859 MASSACHUSETTS AVENUE
FEASIBILITY STUDY
CAMBRIDGE, MA

JULY 18, 2016

YWCA REVIEW AND HMFH RESPONSE

YWCA comments on the Draft Plans with HMFH responses in red italic:

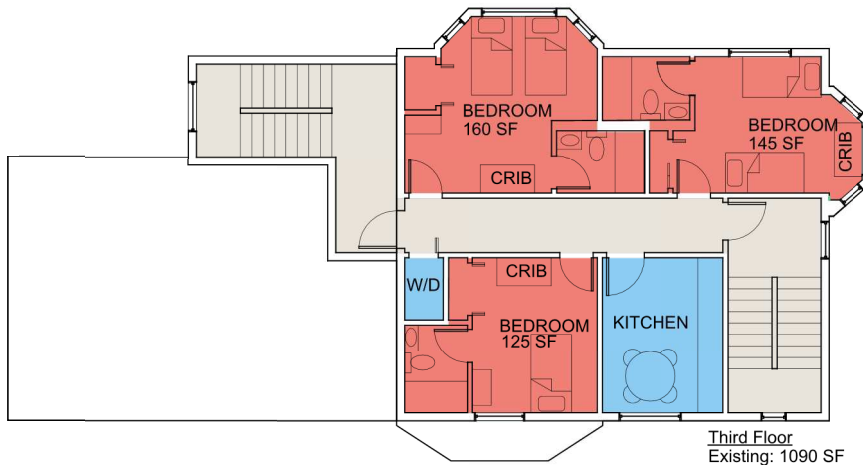
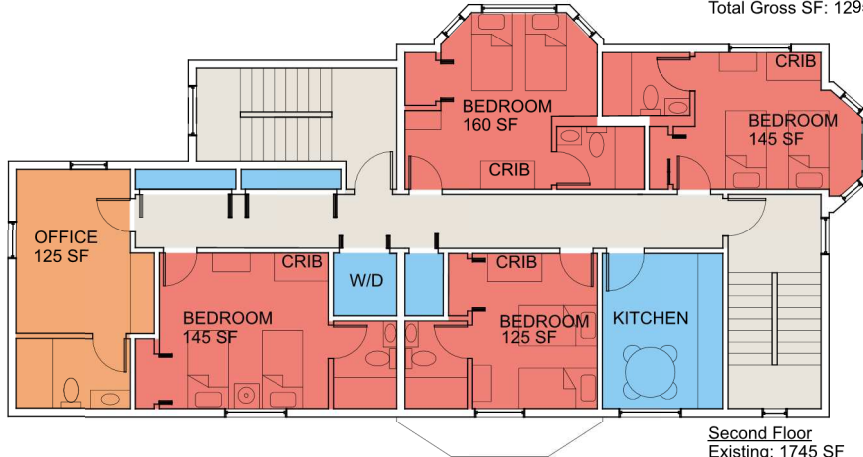
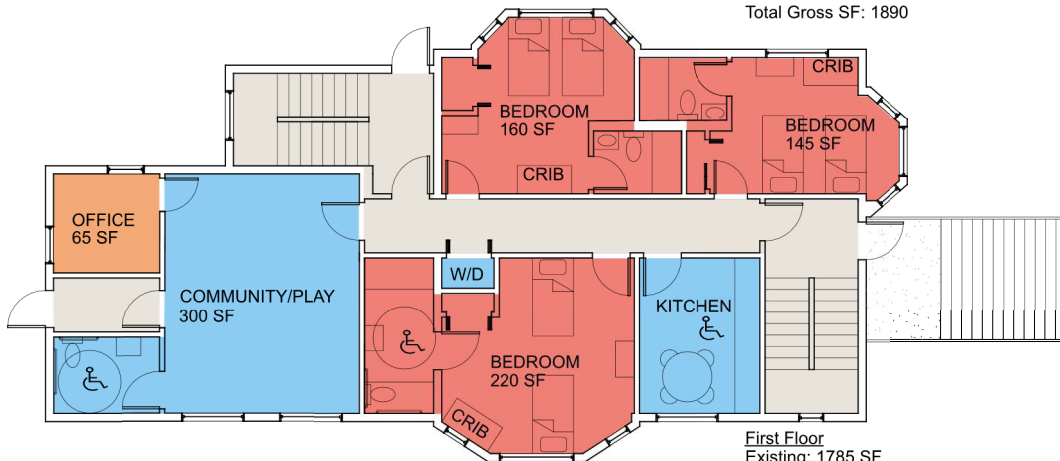
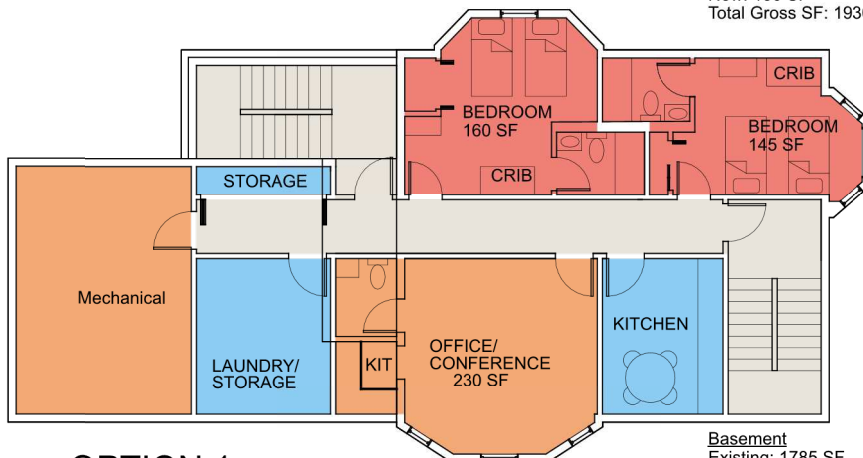
1. The office on the first (ground) floor needs to be closer to, if not immediately adjacent, to the main entrance. Otherwise, staff can't see who is coming and going in and out of the building.
HMFH response: There is an office by the entrance in both options.

2. We can't tell from the schematics whether the kitchens are designed to eat in. They need to be. Otherwise, the families will have to eat in their rooms.
HMFH response: Kitchens are eat-in in both options. A table and chairs are now shown on the plans.

3. There needs to be a laundry room in the building.
HMFH response: There is a laundry closet on each floor with the ability for a laundry room in the basement in both options.

4. There needs to be storage space in the building.
HMFH response: There is room for storage space in the basement in both options.
5. The rooms don't appear to have closets. Each room should have a closet.
HMFH response: All bedrooms have closets in both options.

6. The smallest bedroom on the second floor should be designated as another office.
HMFH response: This was done.
7. The basement office should be designated as a meeting/conference space.
HMFH response: This was done.

1. The windows on the basement and ground level need bars or some other mechanism that prohibits the residents either from sneaking out of the building or from sneaking "visitors" into the building.
HMFH response: This will be included in the estimate.
2. In addition to the usual alarm systems, we would like an internal system in the offices and common areas that enables staff to signal that they are in trouble/need help.
HMFH response: This will be included in the estimate.
3. Having walked around the building, we are concerned about the amount of outside space available for trash bins. At 3 Bigelow, we maintained six (6) trash bins and two (2) recycling bins.
HMFH response: A trash area will be shown on the site plan.
